H12030

## DESCRIPTIVE REPORT

# Descriptive Report to Accompany Hydrographic Survey H12030

**Revisions and Corrections Compiled During Office Processing and Certification**

Figure 1: H12030 Survey Outline and Junctions

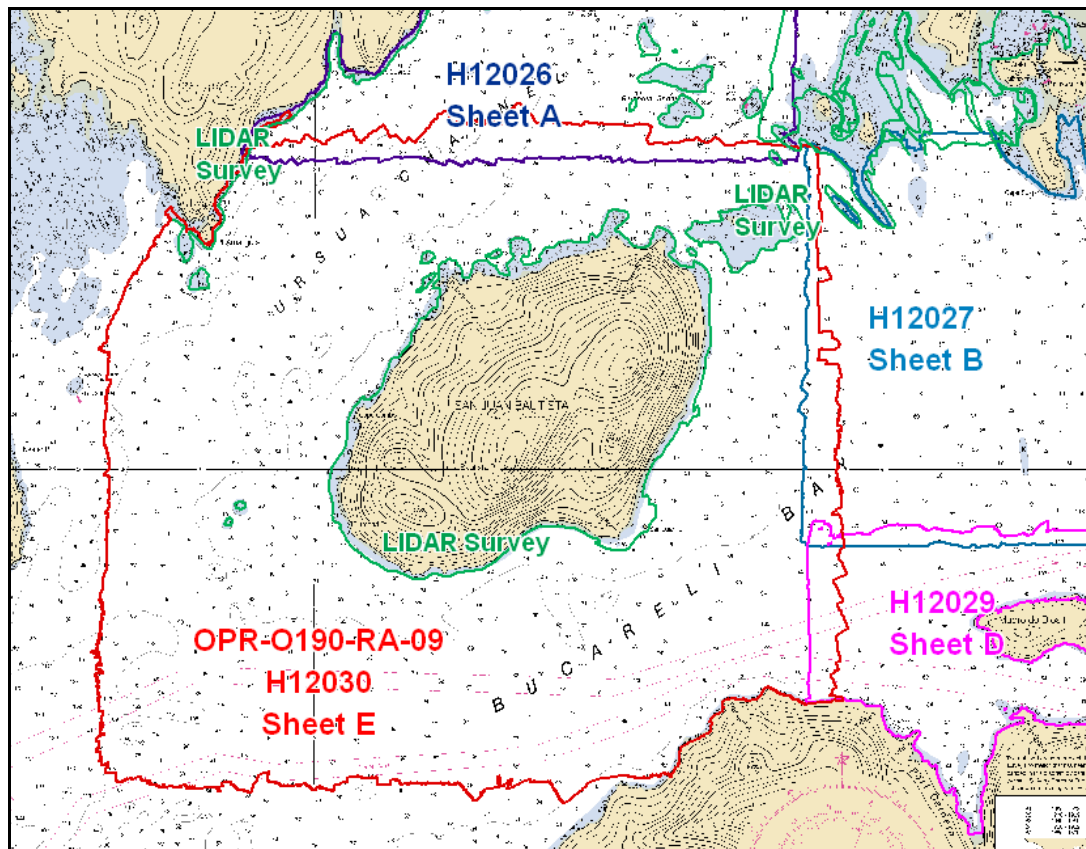
Survey H12030 junctions with surveys H12026, H12027, and H12029, which are sheets A, B, and D of the same project, respectively.<sup>3</sup> Survey H12030 also junctions with H11659, H11660, H11661, H11662, and H11663, Tenix LADS LIDAR surveys from project OPR-O190-KRL-07.<sup>4</sup> The sheet limits and area of overlap for multibeam and LIDAR surveys are shown in Figure 1.

Caris LIDAR BAGs for H11659, H11660, H11661, H11662, and H11663 were provided by Pacific Hydrographic Branch for junction comparison. H12030 BASE surfaces were compared to this junction surface in Caris Notebook. All surfaces were found to be in good general agreement within one meter.<sup>6</sup>

<sup>3</sup> Concur with clarification. There is a very small area in the northeast corner of H12030 that junctions with H12000. A common junction was made with H12026, H12027 and H12029, all of which have already been compiled. A partial junction was made with H12000 which is being concurrently compiled.

<sup>4</sup> Do not concur. H12030 only shares a common junction with LIDAR survey H11662. H12030 also shares a junction with a part of LIDAR survey H11867, which was collected a year after H12030 was completed. Portions of LIDAR surveys H11662 and H11867 were compiled concurrently with H12030 and are included in the HCell.

<sup>6</sup> Concur with clarification. The junctioning data from H11662 was found to be in good agreement within 1 meter. The junction with H11867 was evaluated during compilation and it was found to be in good agreement with both H12030 and H11662, however it was slightly shoaler than H11662. In areas where LIDAR surveys H11662 and H11867 overlap, H11867 was used for compilation.

Figure 2: Sound velocity artifact resulting from a malfunctioning surface sound velocimeter viewed in Caris HIPS subset mode

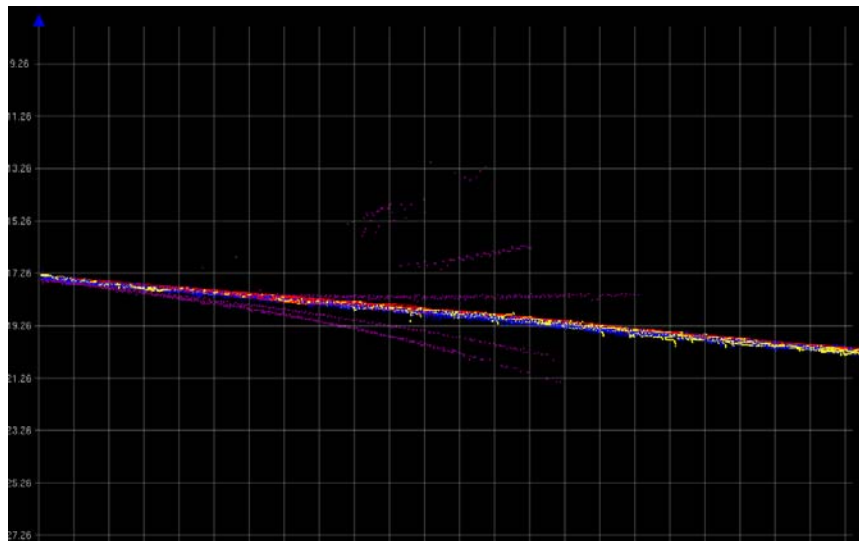
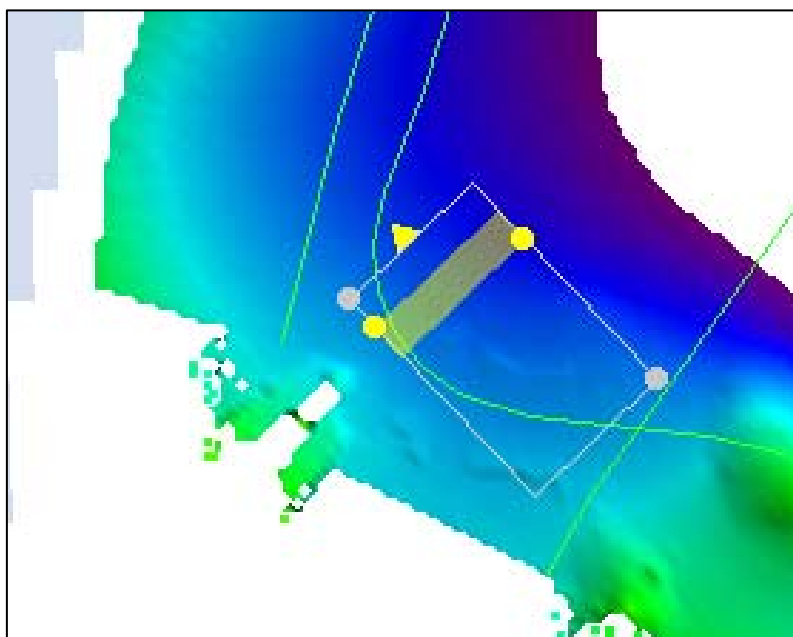
Multibeam echosounder data acquired with 1101 (RA-1) tilted Reson 8125 displayed several momentary sound velocity ‘blowouts’ where the vessel’s Digibar surface sound velocimeter was not reading the proper surface sound speed. Because this sonar uses surface sound speed input for beam forming, it was impossible to correct this data. To compensate, the Hydrographer, where possible, rejected soundings obviously in error on the outer beams.<sup>7</sup> See Figures 2 and 3 below.

<sup>7</sup> After rejecting the data resulting from the surface sound speed dropouts, the remaining data meets specification and is adequate for charting.

*Figure 4: The BASE surface reflected the sub-bottom characteristics of the survey area (viewed in Caris HIPS subset mode)*

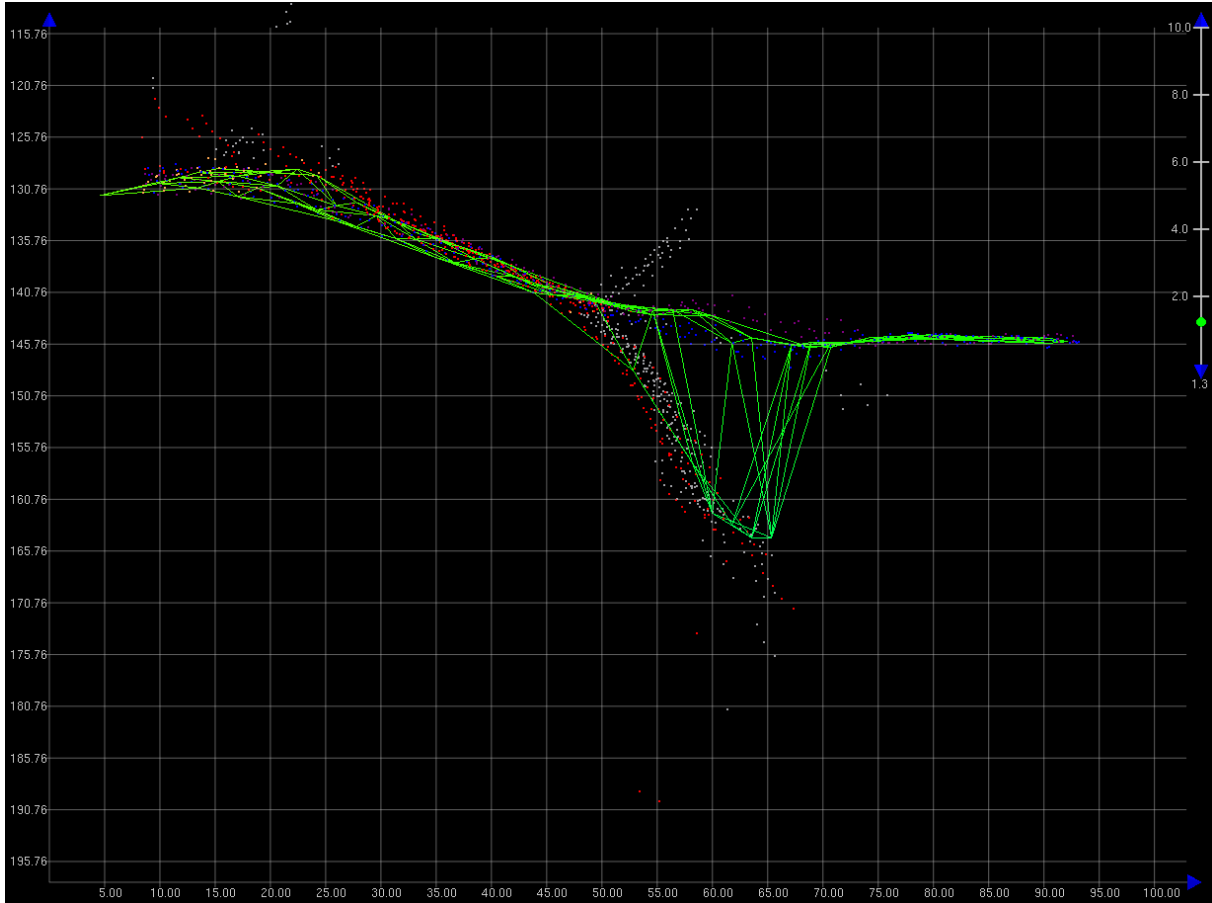
The bottom type found in the vicinity of San Juan Bautista contained areas of drastically-varying bottom type. There were many instances seen where soft mud was found adjacent to and on top of a harder, rocky bottom type. In these cases, the Reson 7125 appeared to penetrate the mud bottom and returned the rock substrate beneath. This was especially common when running in low frequency in deeper waters. The CUBE surface often chose the sub-bottom return, causing a trough at the rock-mud interface. Multiple lines were run in these areas in an effort to capture the true seafloor. To further compensate, the Hydrographer, where possible, rejected soundings obviously below the surface.<sup>8</sup> See Figure 4 below.

<sup>8</sup> After rejecting the sub-surface data, the remaining data represents the true characteristic of the seafloor within specification and is adequate for charting.

Figure 7: Incomplete contour lines, highlighted with red circles, in the southeastern portion of survey H12030 on chart 17405

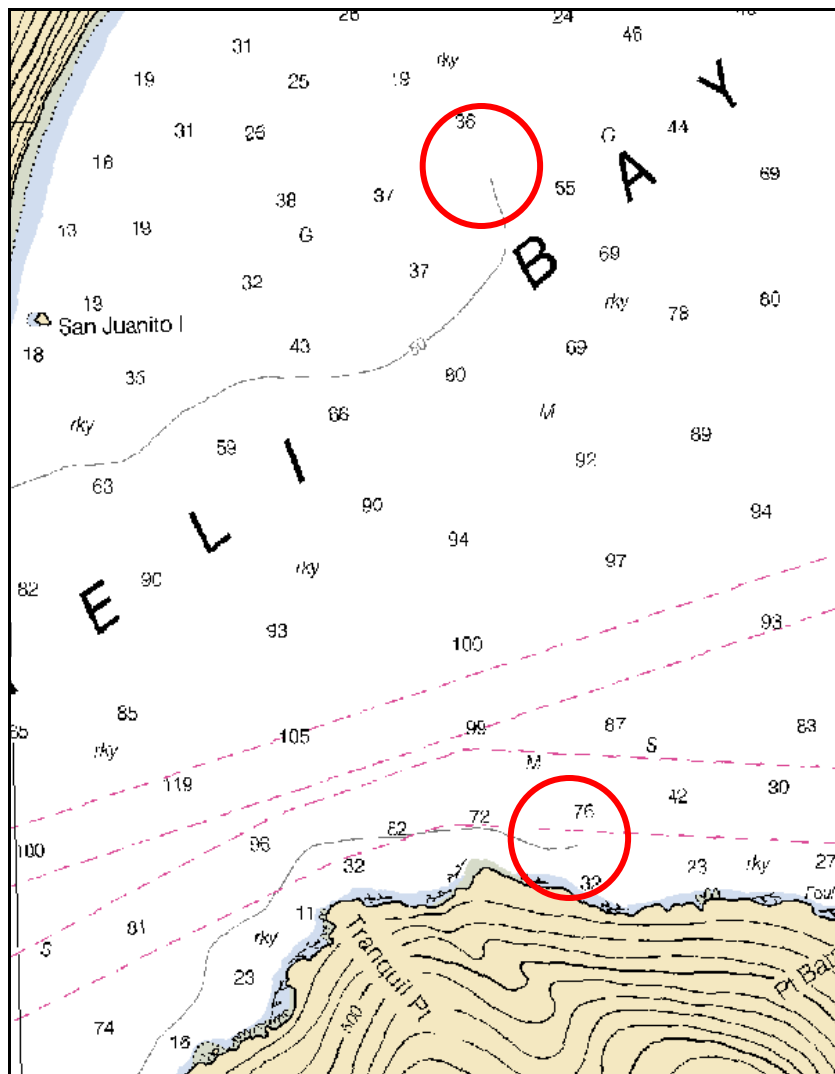
Contours generally agreed between chart 17405, chart 17406, and survey H12030; no notable contour shifts were seen between chart 17406 and survey soundings.<sup>12</sup> On chart 17405 the 100-fathom depth contour in the southwestern corner of the survey is depicted well, but an area of survey soundings deeper than 100 fathoms were missed in the southeastern corner of the survey. The 50-fathom curve is mostly charted correctly, with only minor discrepancies throughout the sheet, most likely due to the sparseness of data from the previous surveys. The two 50-fathom contours in the southeastern portion of the sheet near San Juanito Island and Tranquil Point are incomplete; the contour lines end abruptly and do not close around an area (Figure 7). The Hydrographer recommends updating the depth contours and completing the 50-fathom contours from the digital data acquired on sheet H12030.<sup>13</sup>

<sup>13</sup> Concur.

Figure 8: Comparison of survey soundings with charted depths from chart 17405 for field sheet H12030\_A of survey H12030. Red dots indicate shoaling, blue indicate soundings deeper than charted, and green indicate chart-survey agreement

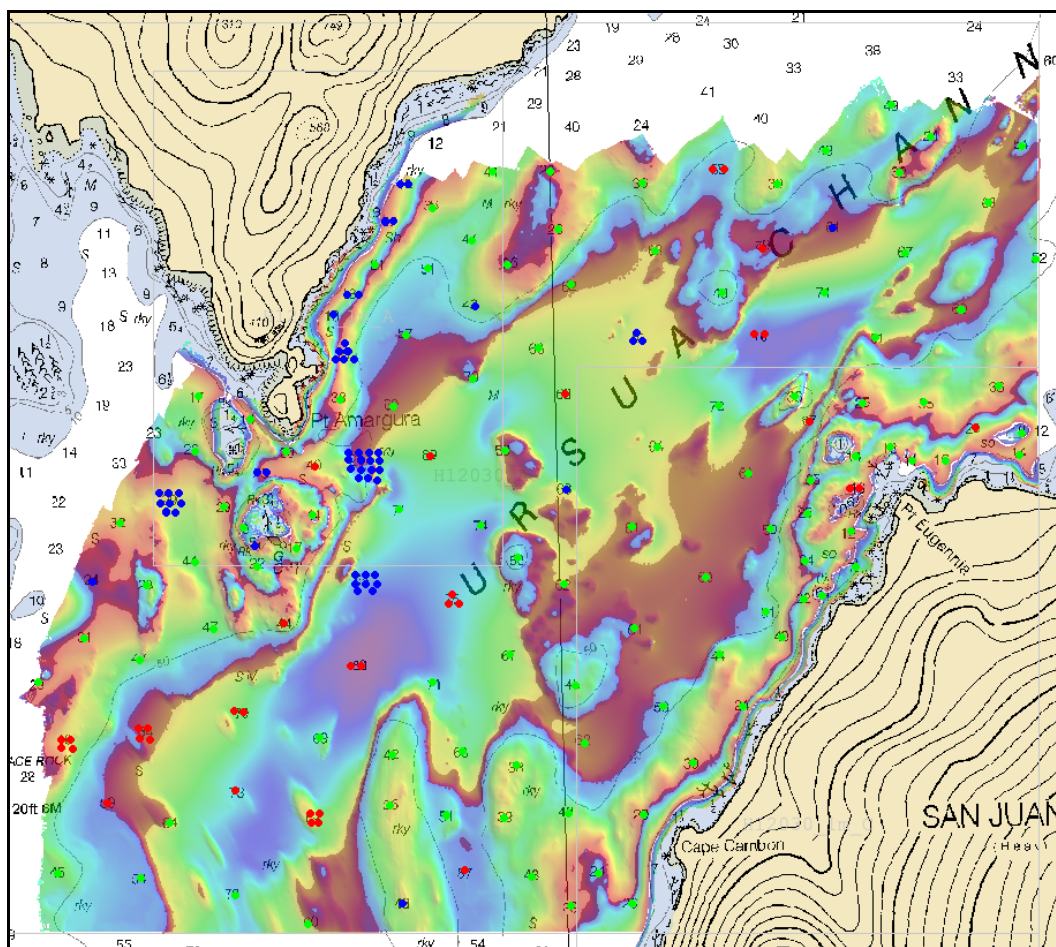
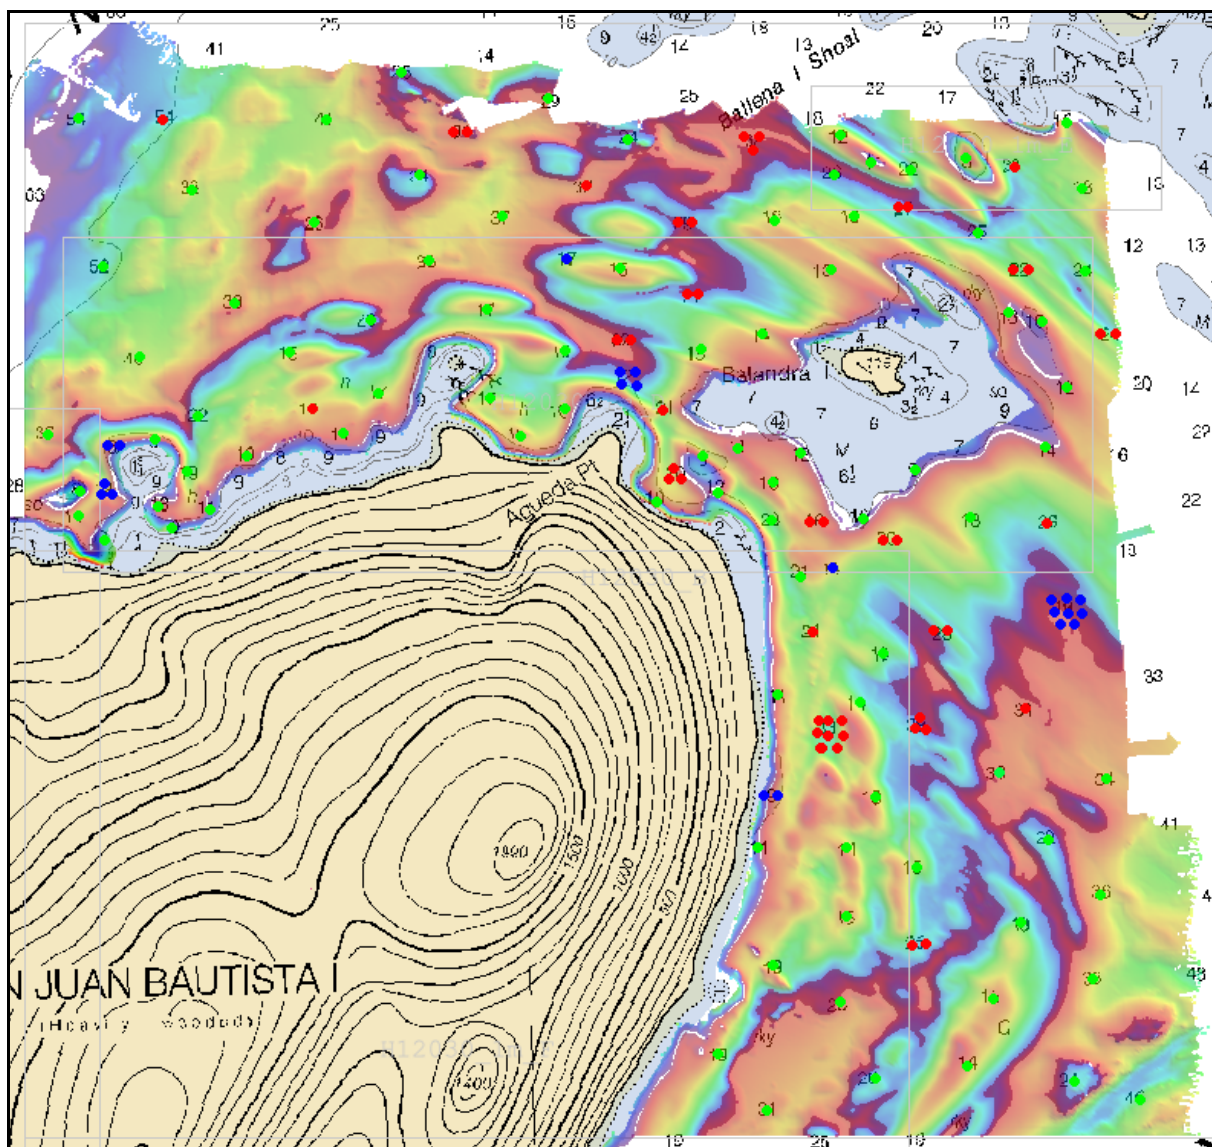
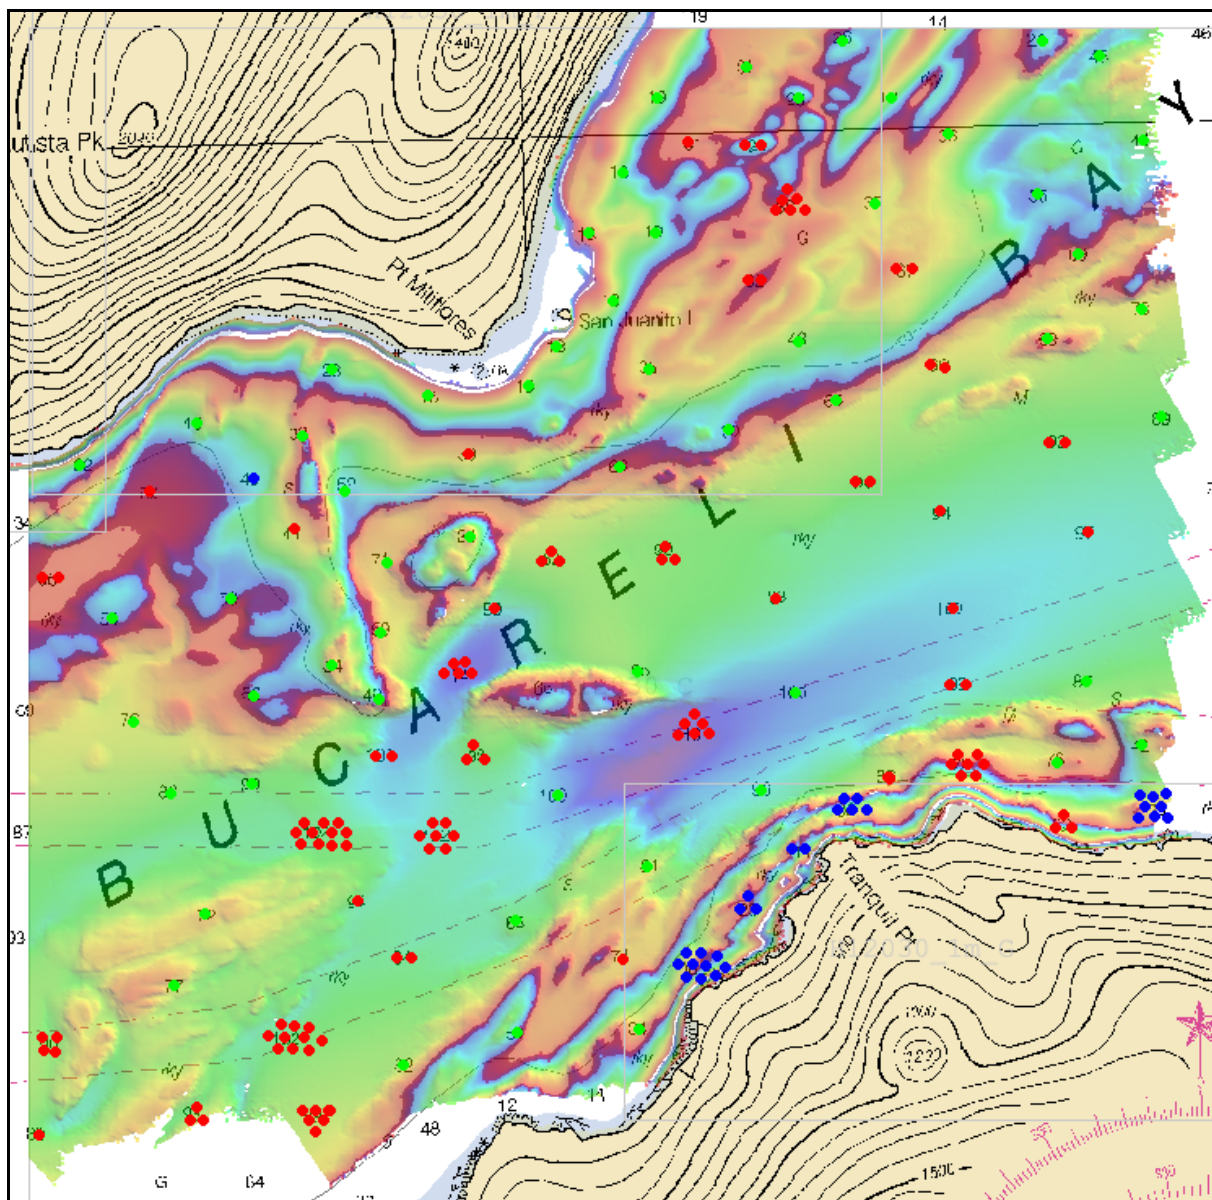
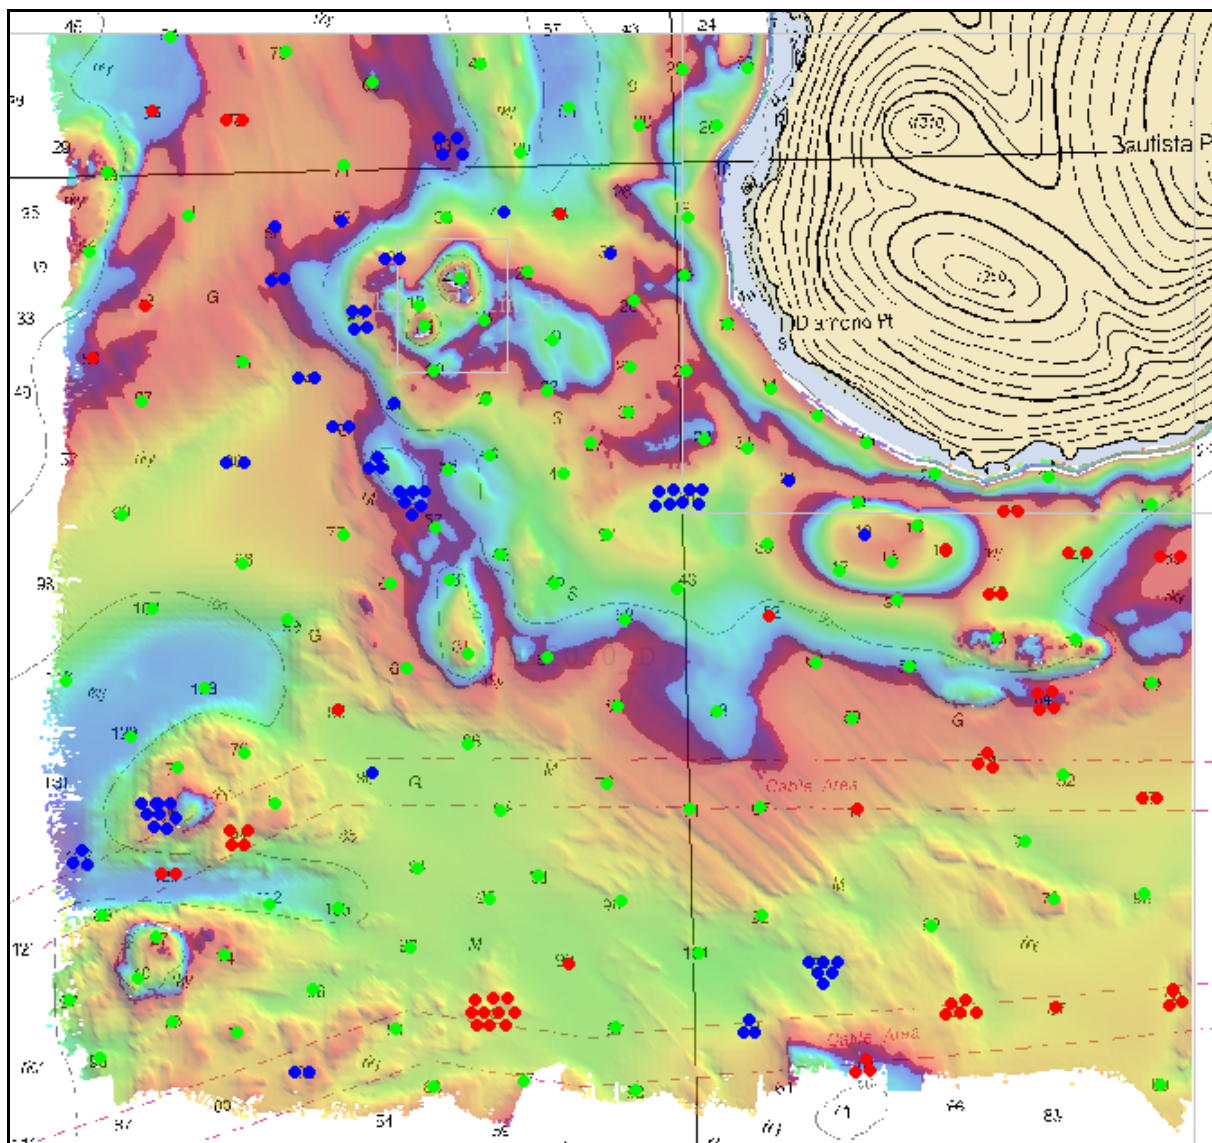
Significant instances of discrepancies include: The two shoal areas in the vicinity of position 55° 24.6'N 133° 21.3' W were both found to be 0.5 ftn deeper than charted. The 33 ftn charted depth at approximate position 55° 26.1'N 133° 13.5'W was found to be much shoaler than with survey soundings ranging from 11 to 18 ftns.<sup>15</sup>

The Hydrographer recommends that survey soundings supersede all prior survey and charted depths in the common area.<sup>16</sup>

<sup>15</sup> Compiler concurs with the field comparison results.

<sup>16</sup> Concur.

Figure 12: H12030 Cable areas

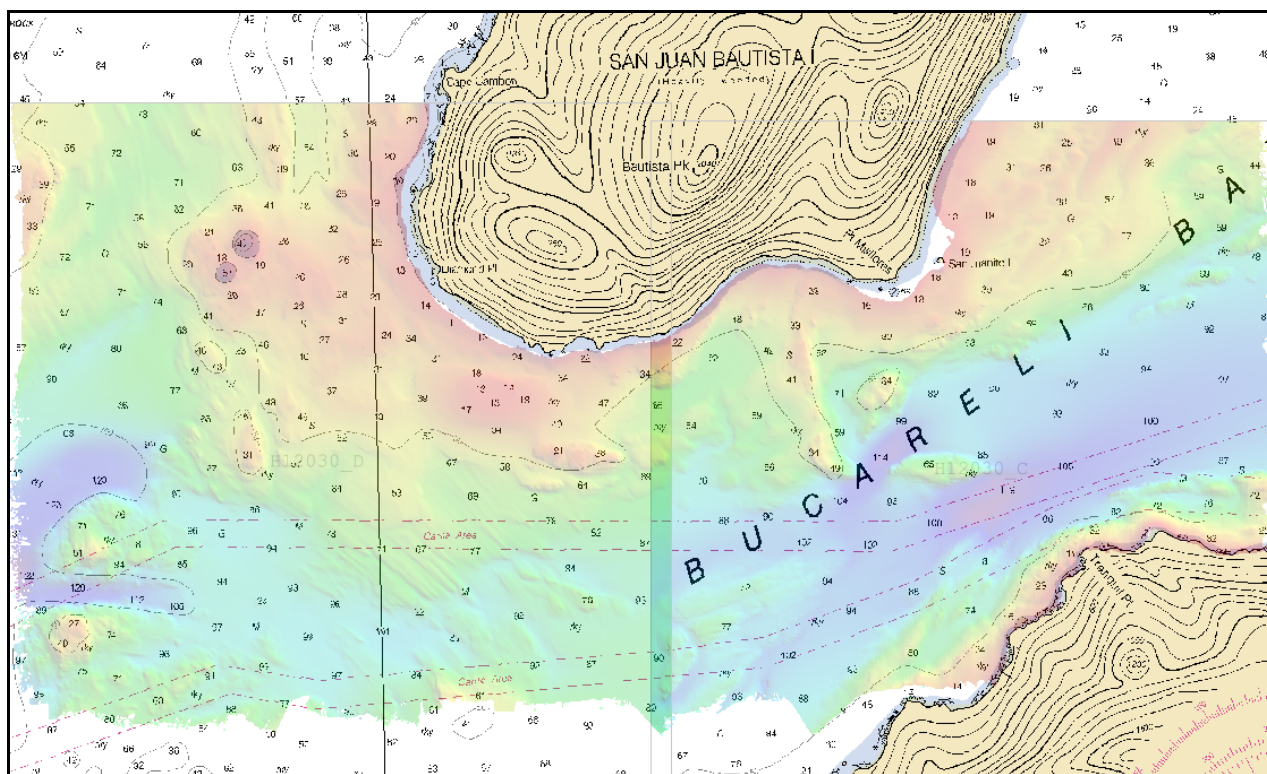
Survey H12030 contains two charted cable areas south of San Juan Bautista Island, as shown in Figure 12. No visible indication of cables was evident in the MBES data in the cable area depicted on chart 17405 or 17406. The Hydrographer recommends retaining the cable areas as charted.<sup>24</sup>

<sup>24</sup> Concur. The cable areas have been blue noted to be retained in the HCell.
